COMMISSION OF ARCHITECTURAL REVIEW
STAFF REPORT
March 27, 2018, Meeting

20. COA-031861-2018 (B. Englander)

**530 North Boulevard
Boulevard Old and Historic District**

Project Description: **Construct a multifamily building on a vacant lot.**

1925 Sanborn Map

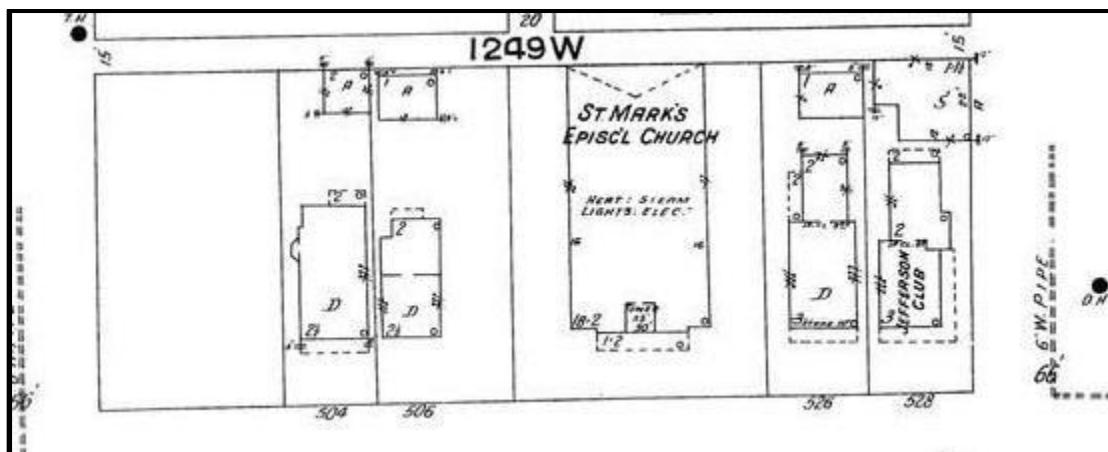
The applicant has not provided a context site plan. The applicant is proposing to setback the south corner of the structure 8 feet from North Boulevard, and at the north corner, the building will be setback approximately 15 feet. Staff believes the structure will sit proud of the adjacent historic structure. Staff recommends the proposed front yard setback from North Boulevard should match that of the historic structure to the south.

The property is a corner lot with one adjacent structure. The historic setback pattern on the block matches that of the adjacent historic structure.
